## HISTORIC AND DESIGN REVIEW COMMISSION

February 06, 2019

**HDRC CASE NO:** 2019-042  
**ADDRESS:** 125 W ASHBY PLACE  
**LEGAL DESCRIPTION:** NCB 1885 BLK LOT A1  
**ZONING:** R-6, H  
**CITY COUNCIL DIST.:** 1  
**DISTRICT:** Monte Vista Historic District  
**APPLICANT:** Craig Scott/CROSS  
**OWNER:** David and Alicia Garrett  
**TYPE OF WORK:** Basement window installation  
**APPLICATION RECEIVED:** January 22, 2019  
**60-DAY REVIEW:** March 21, 2019

The applicant is requesting a Certificate of Appropriateness for approval to install two transom windows to match the existing windows at the basement level on the west side elevation.

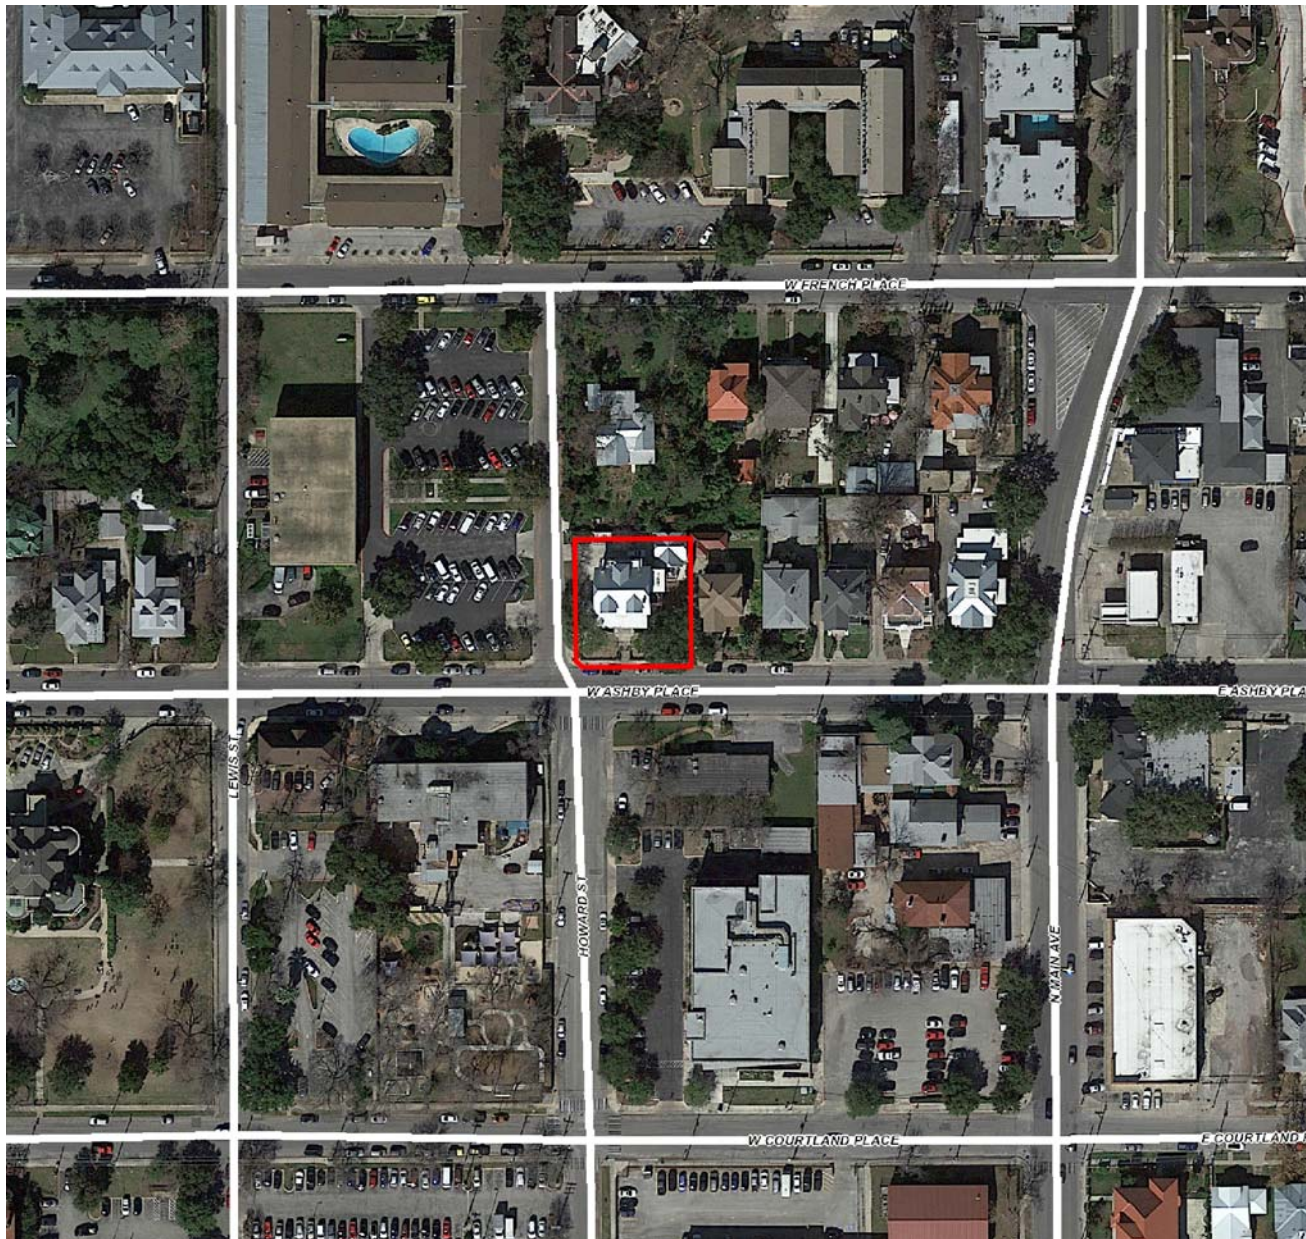
- b. VIOLATION – On a site visit conducted on January 9, 2019, staff found that masonry had been removed from the basement level skirting to install new window openings. After staff notified the contractors of the violation, they were cooperative towards compliance and submitted an application on January 22, 2019, to be heard at the next HDRC hearing.

- c. BASEMENT WINDOWS – The applicant has proposed to install two new transom windows to match the two existing transom windows at the basement level. Per the Guidelines for Exterior Modifications and Alterations 6.A.i., new window openings on the primary façade or visible from the public right-of-way and 6.B.iv., new windows are to match the historic or existing windows in terms of size, type, configuration, material, form, appearance, and detail when original windows are deteriorated beyond repair. Staff finds that the proposed new windows are constituent with the Guidelines as they are located on a side elevation at the basement level and match the existing windows in size, depth, material, and installed in an equidistant pattern. However, staff finds that the historic masonry removed from the new window openings should remain on site for reuse.

Staff recommends approval based on finding c with the following stipulations:

- i. That the new windows match the existing windows in size, depth, material, and installed in an equidistant pattern.
- ii. That the historic masonry removed from the new window openings remain on site for reuse.

WEST EXTERIOR ELEVATION

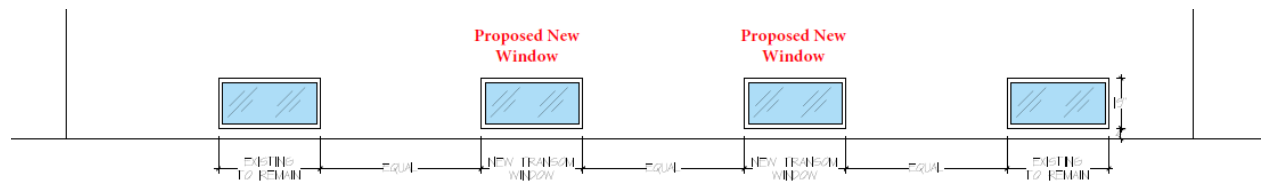
- Homeowners would like to replace two existing windows with the same like and quality
- Create two additional window openings with the same original detail to the basement
- A total of four new awning windows would be installed
- Window Type: MARVIN Wood exterior, size RO 37 3/8" x 19 15/16"
- CROSS will carefully remove the basement exterior brick, to be re-used.
